CONTRACT CHANGE ORDER NO. ____
SHEET ___ OF ___

MARK	DATE	DESCRIPTIONS	BY	CH'D	CCO#
2	01/16/09	BOX GIRDER AXIAL CAMBER	GB	DT	103
1	08/24/07	BARRIER MODIFICATIONS	GB	DT	44

SAN FRANCISCO OAKLAND BAY BRIDGE
EAST SPAN SEISMIC SAFETY PROJECT
SELF-ANCHORED SUSPENSION BRIDGE (SUPERSTRUCTURE & TOWER)

GIRDER FRAMING PLAN NO. 4

CAMBER SCHEDULE-C

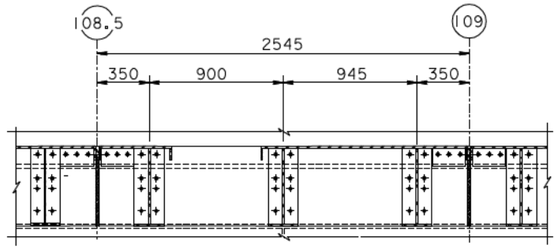
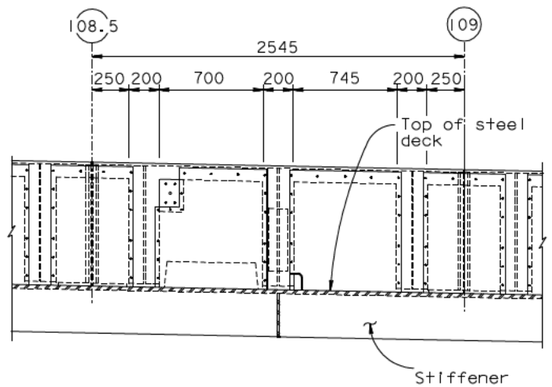
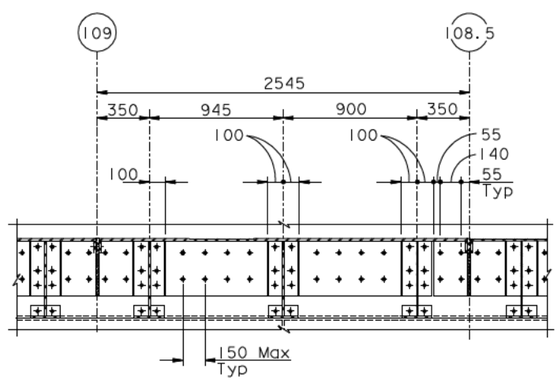
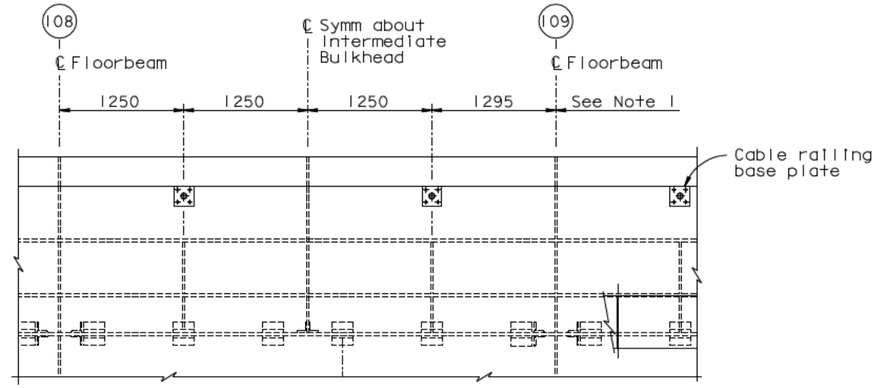
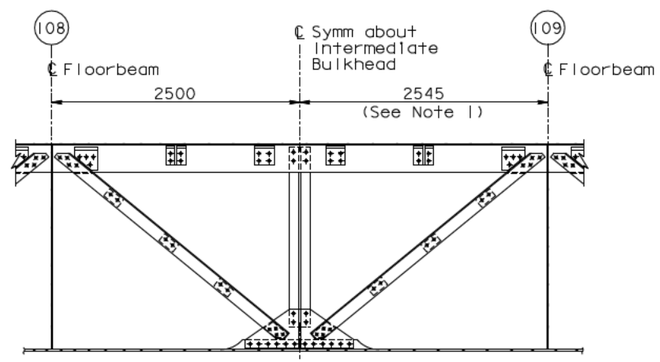
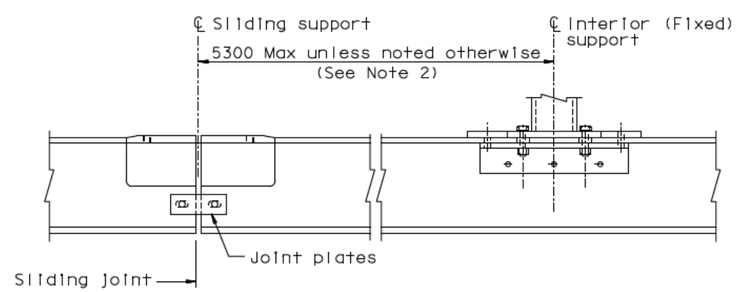
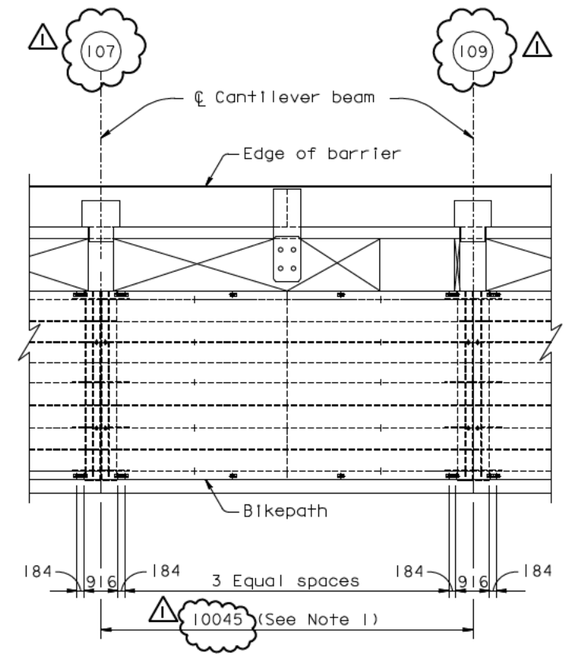
1. Dimensions shown are the final horizontal erected girder dimensions.
2. The final erected girder dimension between PP 108 & PP 109 is 5045.

MARK	DATE	DESCRIPTIONS	BY	CH'D	CCO#
1	04/03/09	BOX GIRDER AXIAL CAMBER	GB	MN	103
0	01/16/09	BOX GIRDER AXIAL CAMBER	GB	MN	103

CAMBER SCHEDULE-D

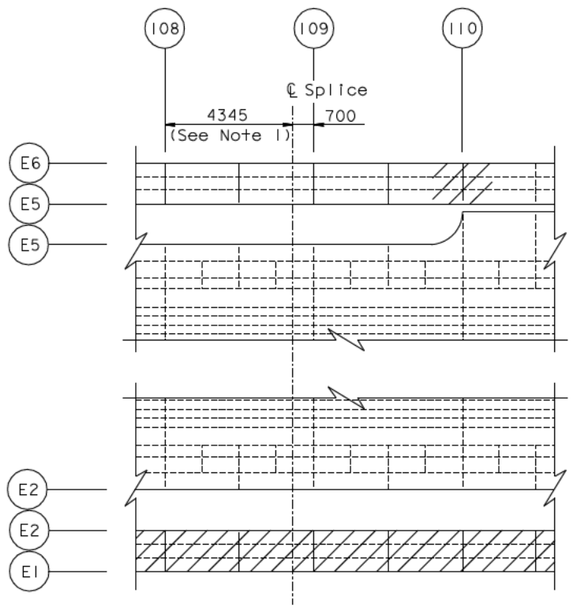
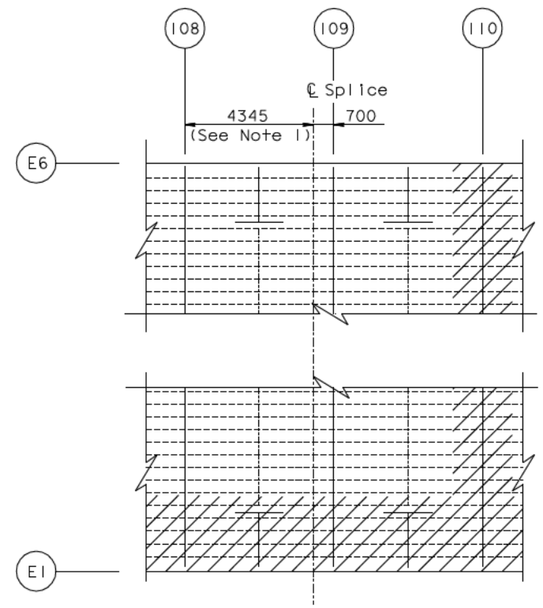
1. Dimensions shown are the final horizontal erected girder dimensions.

MARK	DATE	DESCRIPTIONS	BY	CH'D	CCO#
0	01/16/09	BOX GIRDER AXIAL CAMBER	GB	MN	103

WIND VORTEX GENERATOR PLATES DETAILS

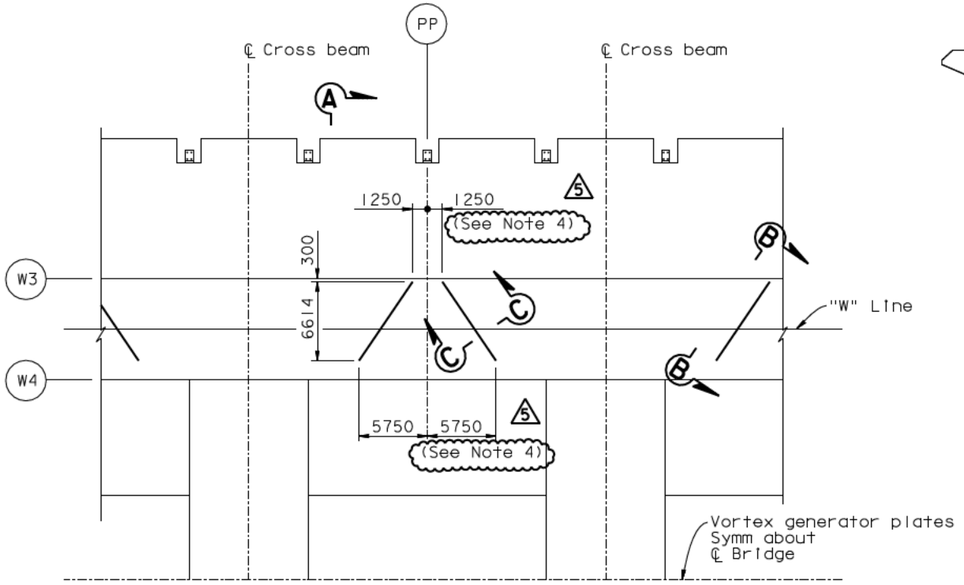
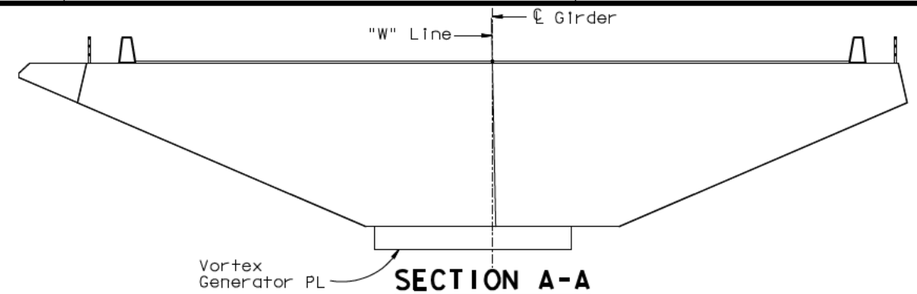
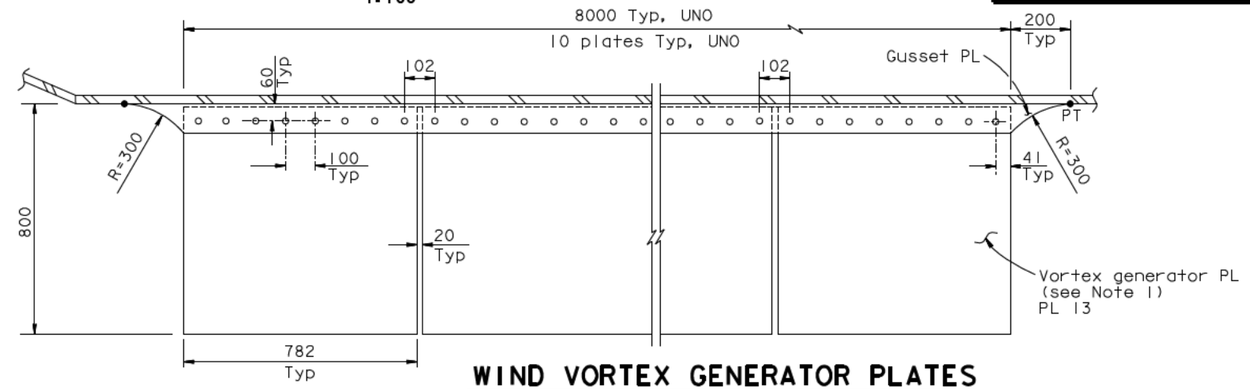
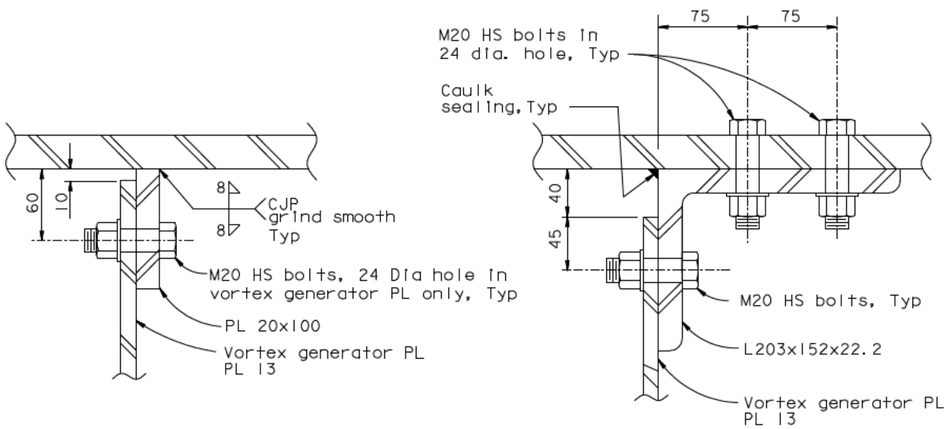
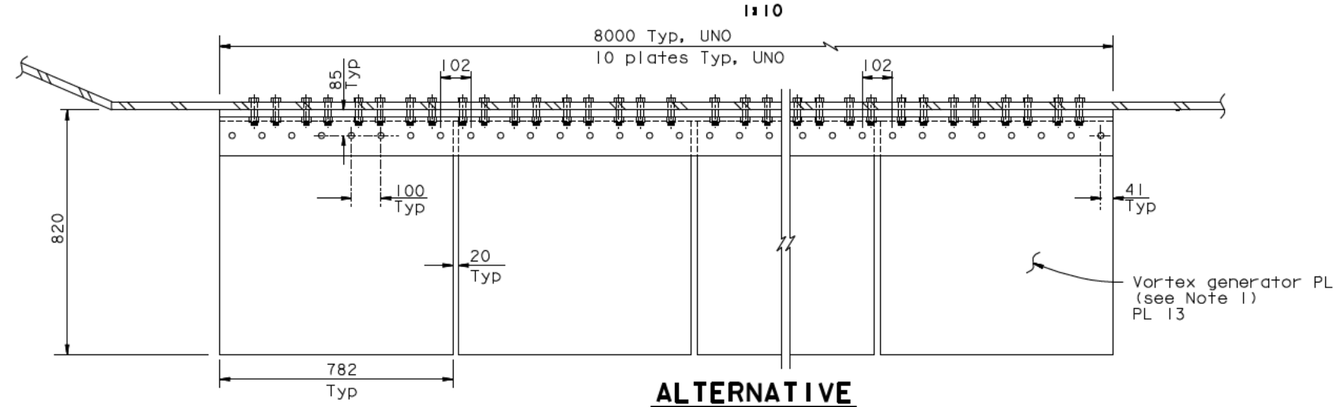
1. A total of 704 vortex generator steel plates shall be fabricated and erected.
2. M20 HS bolts connecting L203x152x22.2 and box girder plate shall clear box girder stiffeners.
3. Installation of vortex generator steel plates shall not interfere with required clearances during construction of the bridge.
4. At PP 108 add 45 mm to the offset shown. (5)

MARK	DATE	DESCRIPTIONS	BY	CH'D	CCO#
5	01/16/09	BOX GIRDER AXIAL CAMBER	JD	MN	103
4	01/16/09	WIND VORTEX GENERATOR PLATES	GB	MN	26
3	07/07/08	CAULKING	AS	MN	66
2	08/31/07	WIND VORTEX GENERATOR PLATES	JD	MN	26
1	07/26/07	WIND VORTEX GENERATOR PLATES	CC	MN	26
